Concept of Operations

Pismo Congestion Relief Project

Left Shoulder Part-Time Travel Lane

v.3.0 Final

Figure 4: Lane-Use Control Signals Mounting: Traffic Signal Pole with Mast Arm, on ground or on median barrier.

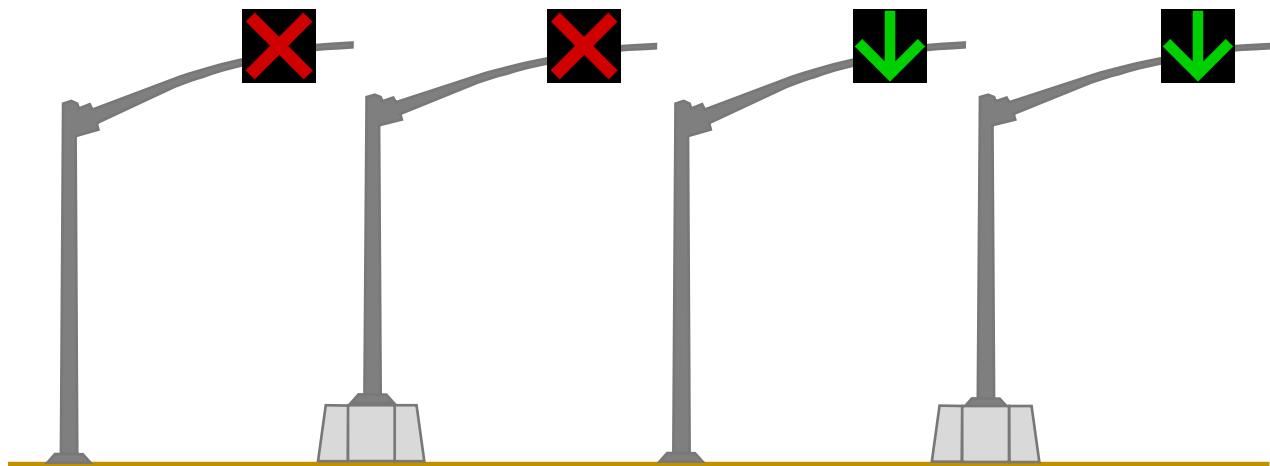
FHWA M. Bhatti	36	6	Figure 4 - It may be worth determining early which "standard Caltrans traffic signal pole or luminaire pole with mast arm" is suitable for this project and whether or not it will require a foundation installation or is the median barrier able to support the signal pole as the type of pole will determine how big of a foundation is needed and if the median barrier is a good enough for support.	Please see response #38.	Signal standard selected per Caltrans standard plan ES-7E, Pole Type 19-3-100, mast arm 25', trimmed to length per project needs.	No action.	✓
FHWA M. Bhatti	37	8	Table 1 - It is suggested that the choice between the two alternatives should be based on where the back of the queue is on daily basis and if there is a way to determine that and an option is picked based on this information.	Agreed and both alternatives presented herein are both capable of congestion relief per Traffic Analysis is documented in the TOAR. TOAR is available upon request.	Continue to seek CHP input. Final locations TBD during PS&E.	On going	On going

Under ConOps v2.1 proposal for all Alternatives. The sign mounted on the lane-use control signal post is to be replaced by this 54"x78" sign as shown.

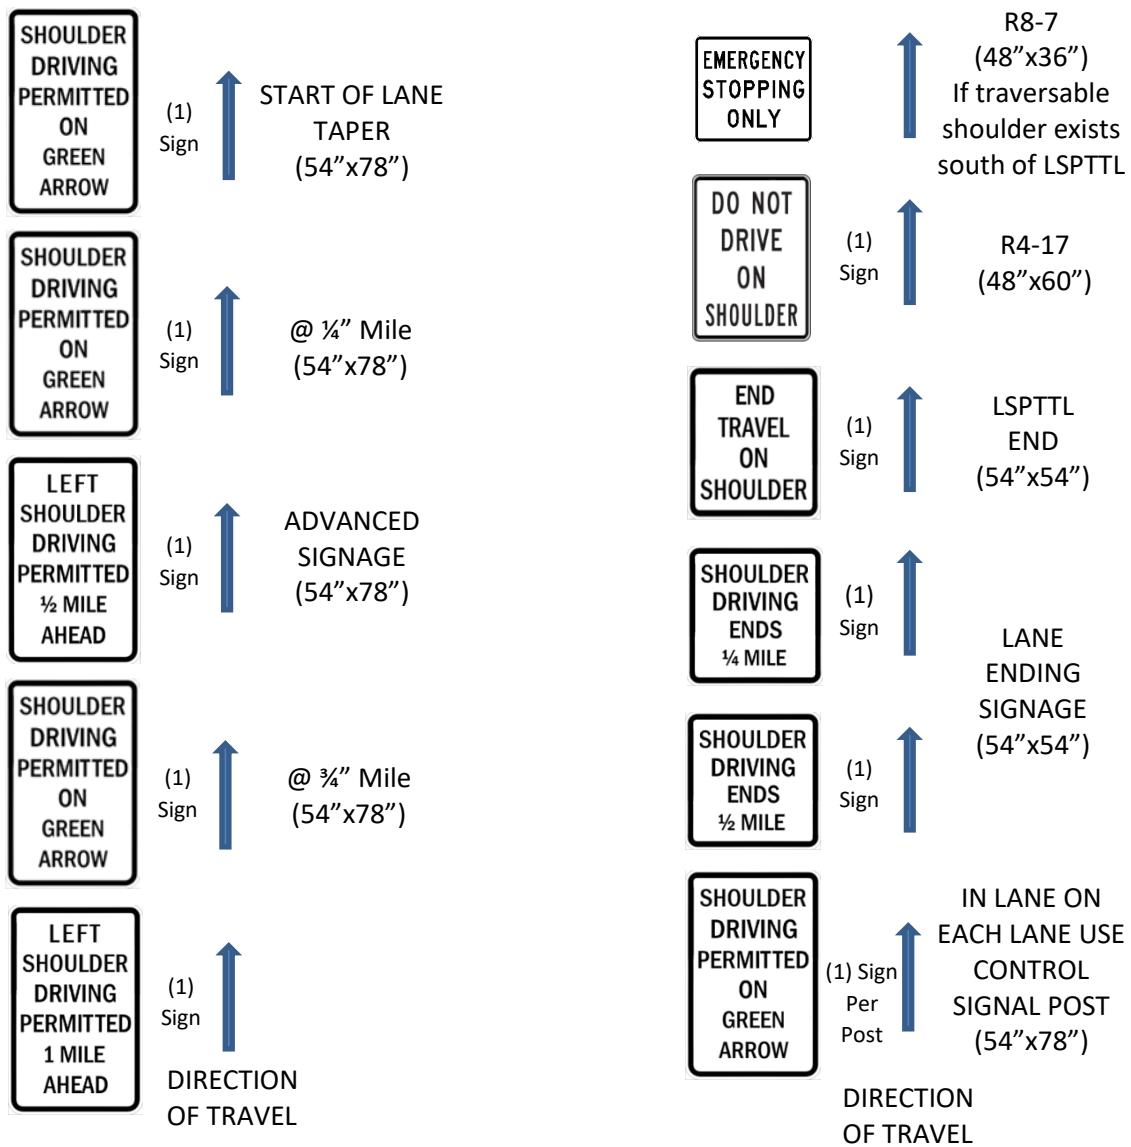
Further consultation with FHWA HQ in Washington D.C. through the Cal-South Office and with the understanding of the sensitive coastal visual impact context high-lighted during the May 6th meeting. FHWA HQ recommends the original large CMS concept be removed and be replaced by smaller road side signs on breakaway wood post to guide the motoring public. They also discourage the use of the phrase "shoulder lane", verbatim "It is confusing as the shoulder is by definition not a lane, i.e. they are either going to add a travel lane or allow travel on the shoulder, it is not both. In this case, where they are only using it for travel a few hours a week during week days, it really operates as a shoulder that travel is allowed on at times. Because of this, they really don't need the type of Guide signs they are proposing where they are treating this as a full-time preferential access restricted lane of some sort. Rather, the signing for this should be rather simple and you don't need much advance signing. The signs for this should be black on white signs with the primary legend being TRAVEL ON SHOULDER ALLOWED."

Hence, Traffic Operations is recommending the following changes that may result in a reduced visual impact to the corridor. Please note that all proposed static signs should be placed on the freeway median area unless right of ways constraint prohibits it. If this situation arises, consultation District Traffic Operations for alternate location for sign placement will be required.
